# Memo

**Application:** Z11-0016

**Address:** 1229 Bothe Road

**Subject:** Rezoning application

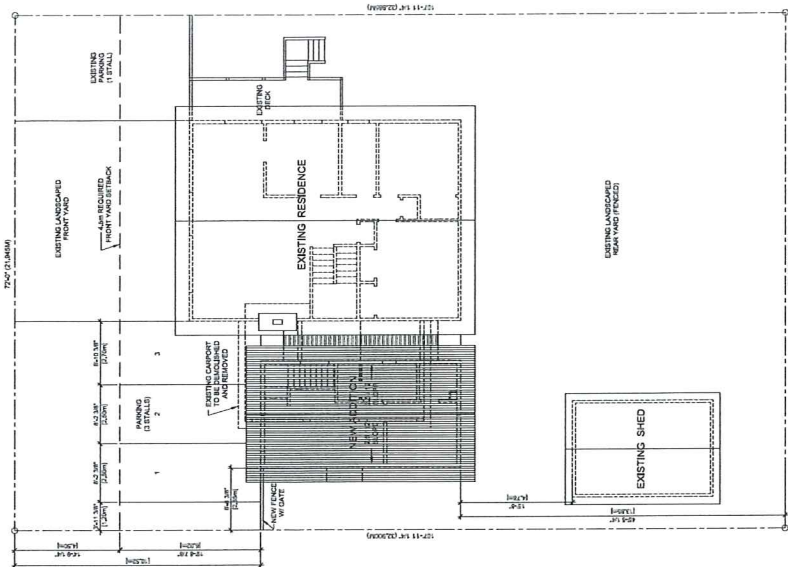
**On-site parking modules must meet bylaw requirements.**

No off-street parking shall be located in the required **Front Yard** except that a maximum of **two** required spaces may be located on a driveway which provides access to a required off-street parking space that is **not in the front yard**.

Provide a Revised Site Plan that meets these requirements.
